REVISION 001 TO A INVITATION TO TENDER

Title - Sujet : Mechanical Systems Upgrade, Battle of the Restigouche National Historic Site		
Solicitation No. - N° de l'invitation : 5P468-21-0158/A	Date : 08 December 2021	
Amendment No. - N° de modification : 001		
Client Reference No. - N° de référence du client : 1408		
GETS Reference No. N° de référence de SEAG : PW-21-00975348		
Solicitation Closes - L'invitation prend fin : At - à : 14 :00 On - le : 16 December 2021		Time Zone - Fuseau horaire EST
F.O.B. - F.A.B. : Plant - Usine : <input type="checkbox"/> Destination : <input checked="" type="checkbox"/> Other - Autre : <input type="checkbox"/>		
Address Enquiries to - Adresser toutes demande de renseignements à : Jaime Creaser		
Telephone No. - N° de telephone : 902-266-8592	Fax No. -N° de télécopieur : 1-877-558-2349	Email Address – Courriel : Jaime.Creaser@pc.gc.ca
Destination of Goods, Services, and Construction - Destination des biens, services, et construction : See Herein

File : Mechanical Systems Upgrade
APC Project : 1408-4

Addendum No : ME-01

PROTECTION INCENDIE SOUS-SOL CONSTRUCTION /
FIRE PROTECTION - UNDERGROUND FLR - CONSTRUCTION

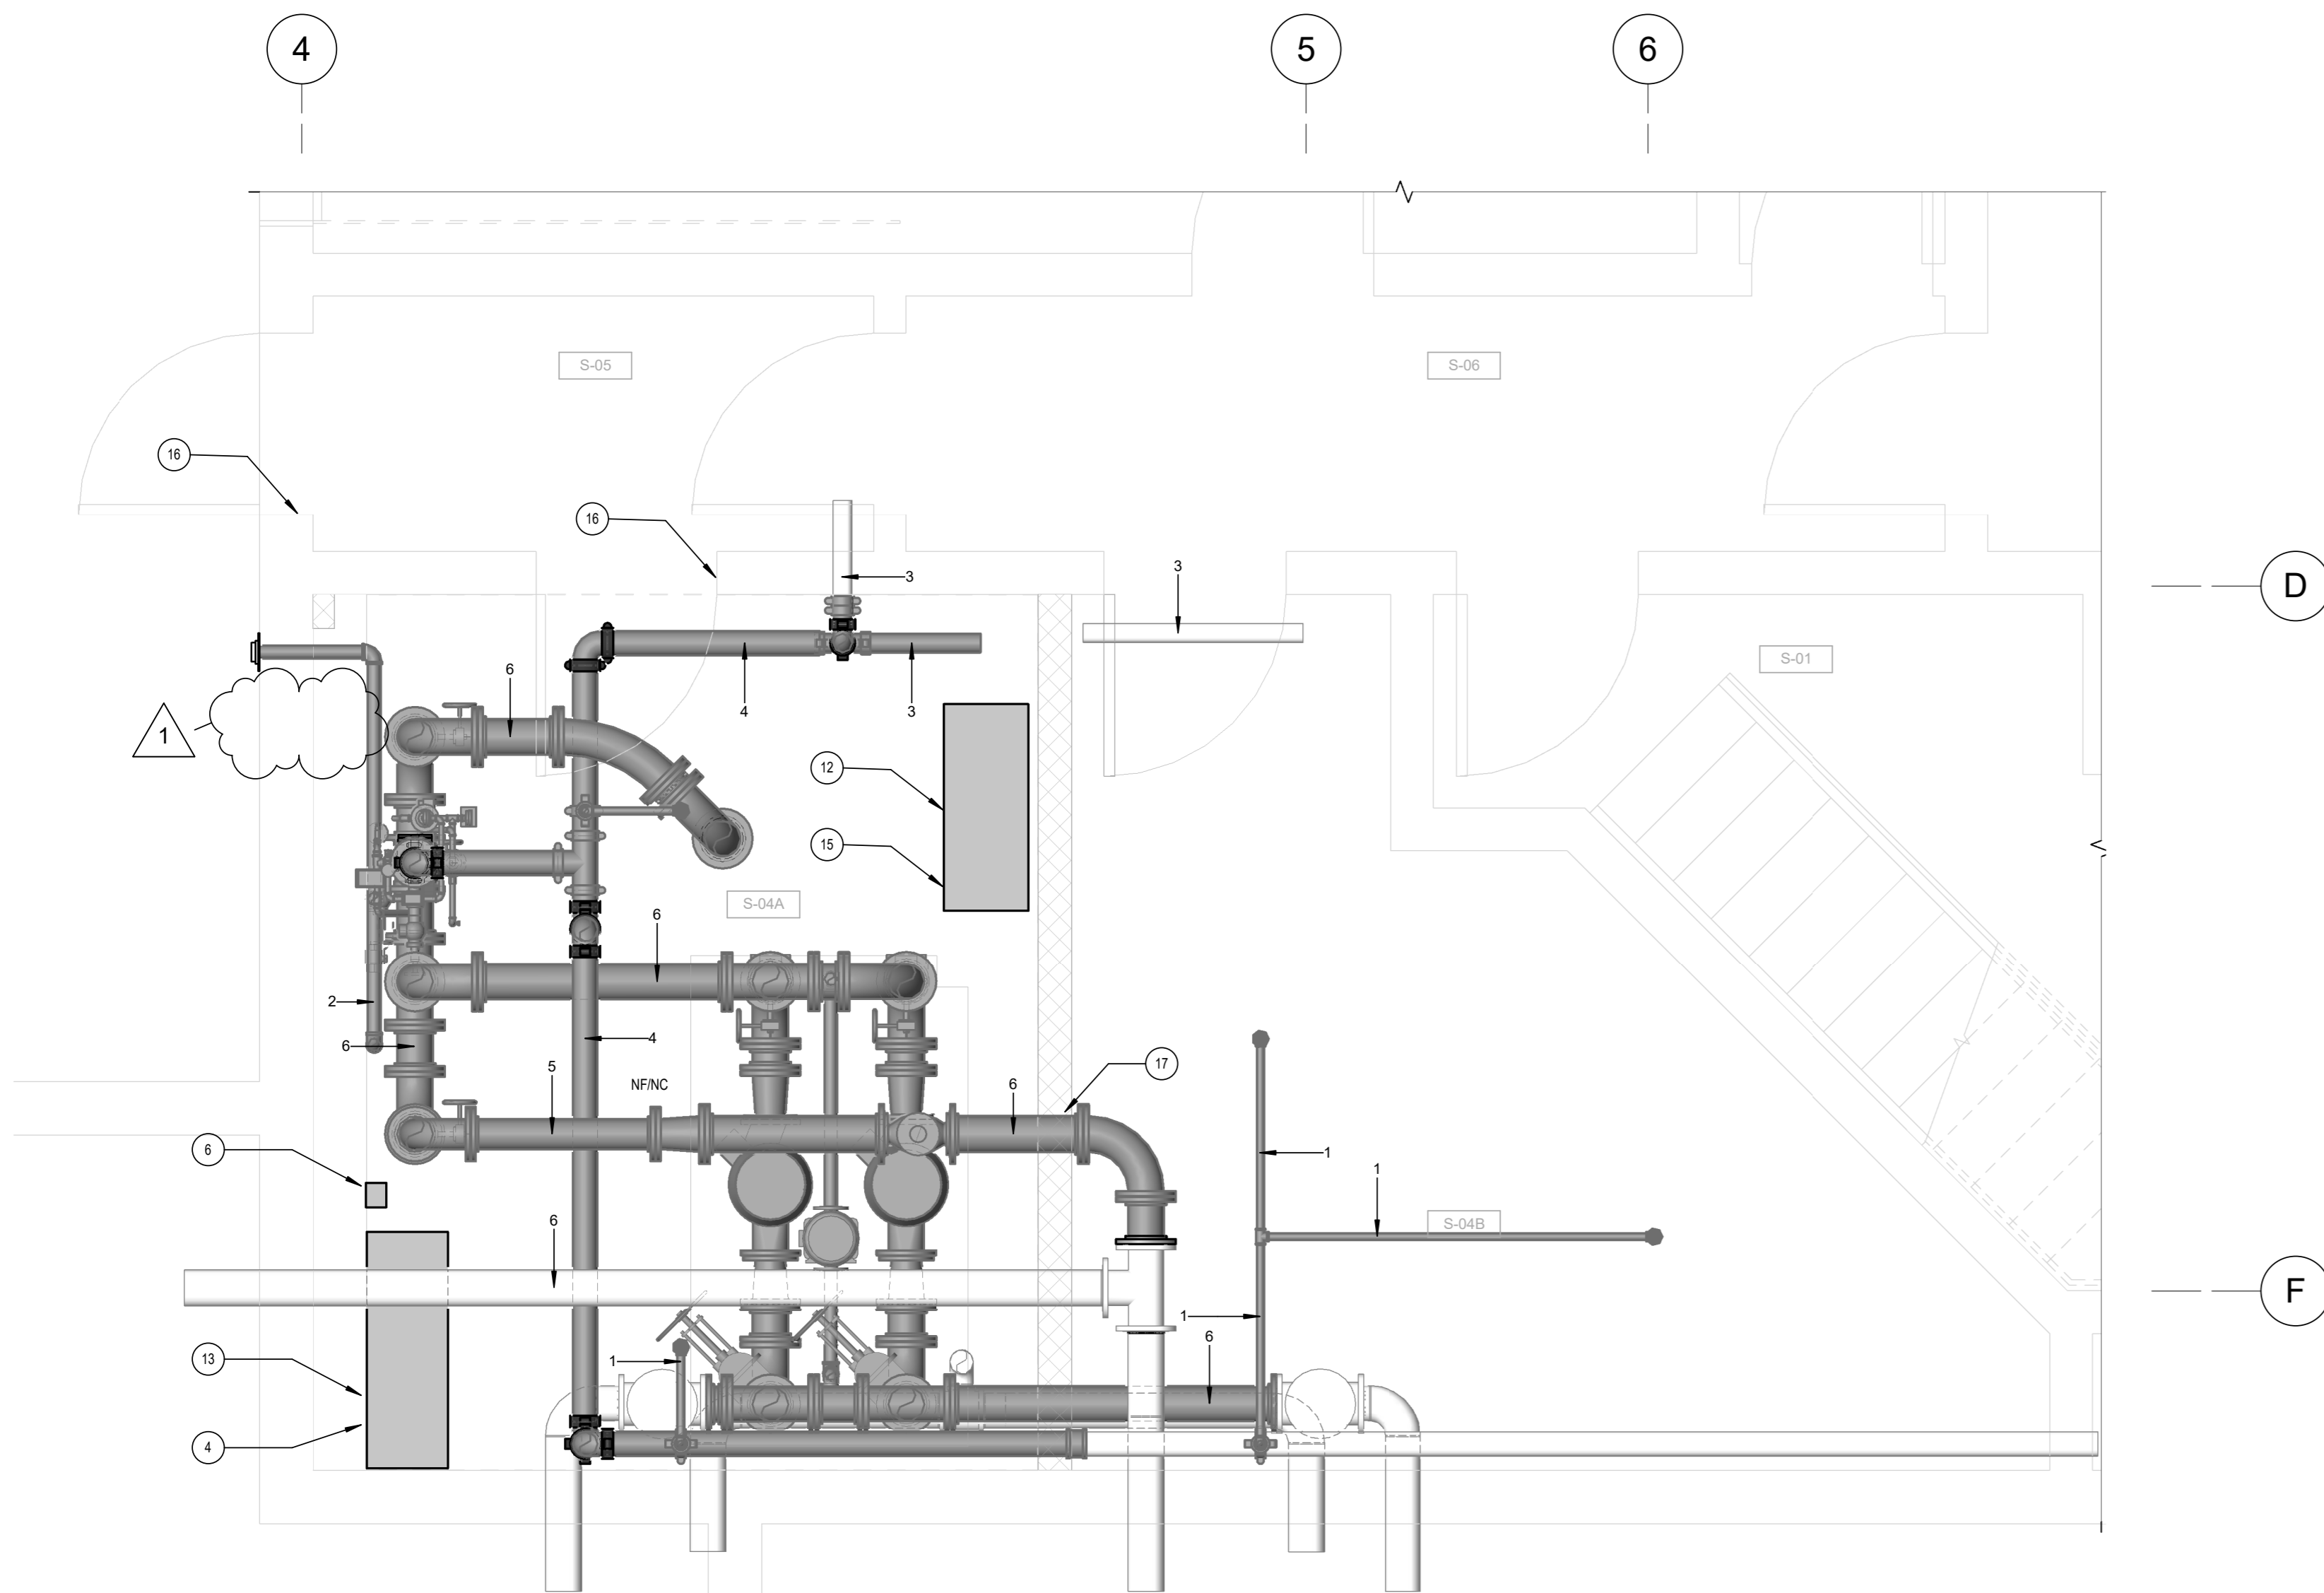
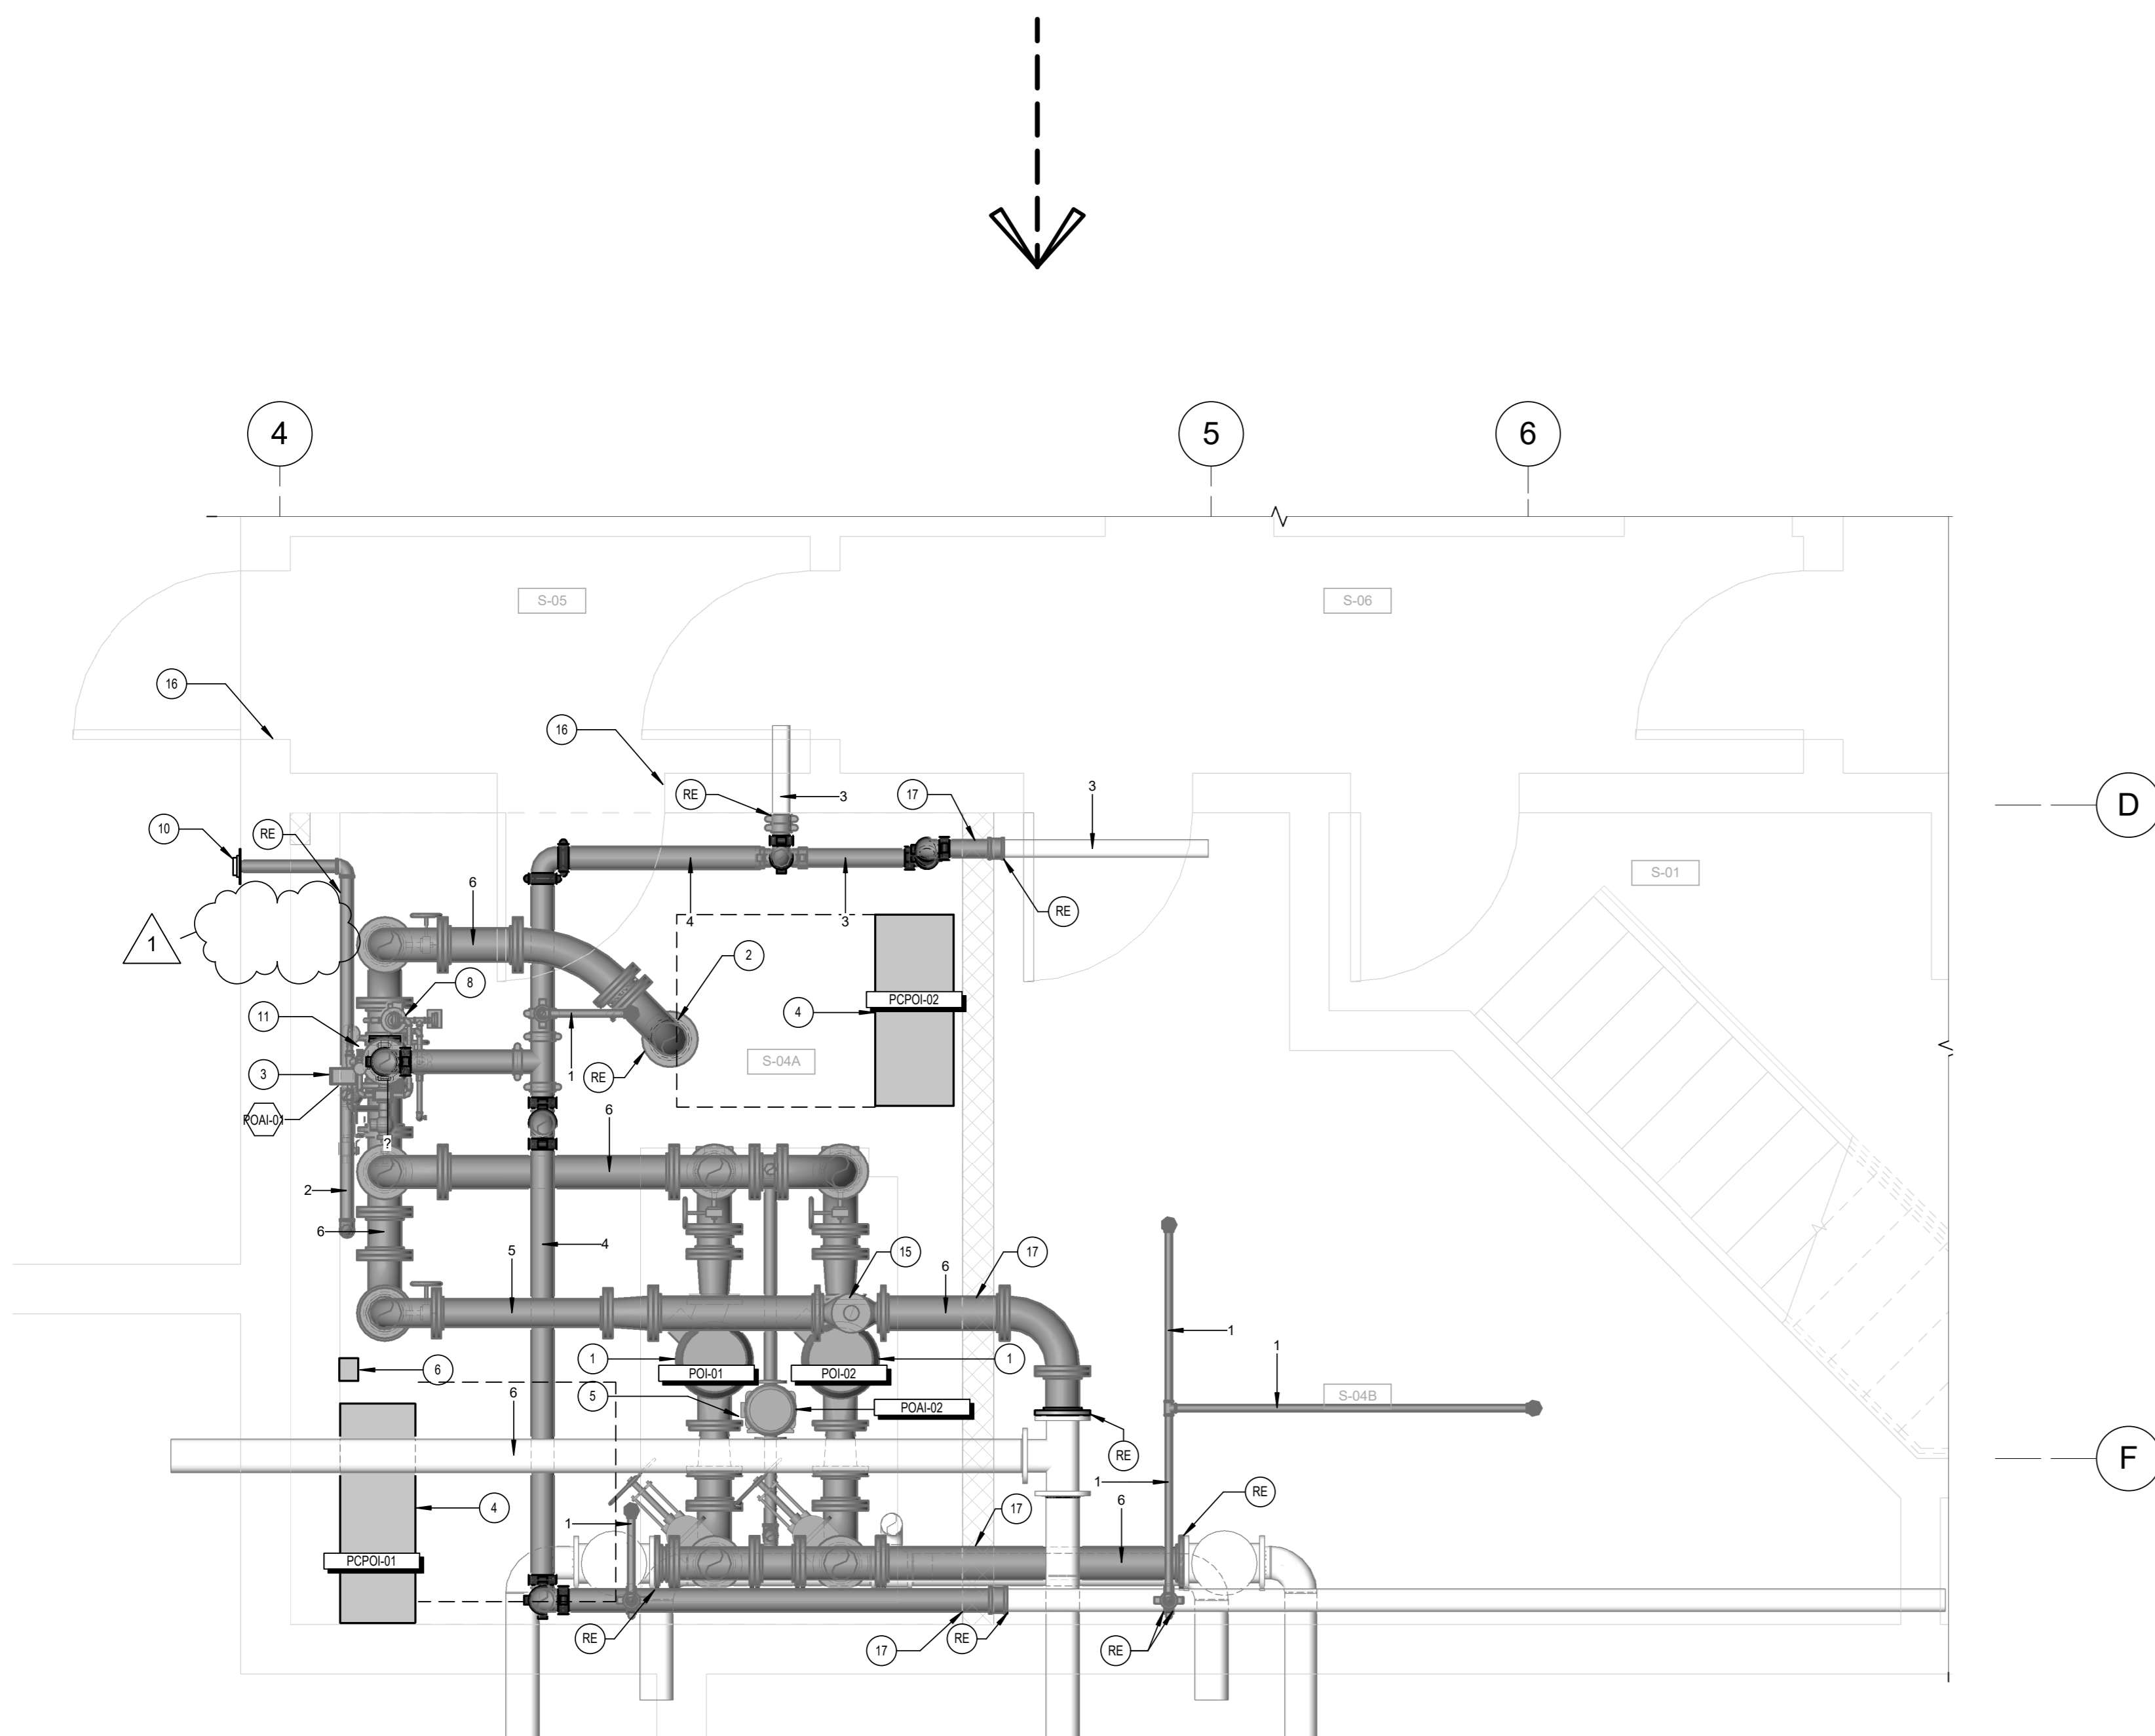
2.1.2 Plan M302 - FIRE PROTECTION - UNDERGROUND FLR - CONSTRUCTION

.1 The existing water motor gong is dismantled and not to be connected to the new alarm valve. Keynotes #7 and #9 are cancelled.

.2 Plan M302 is reissued with revision 1.
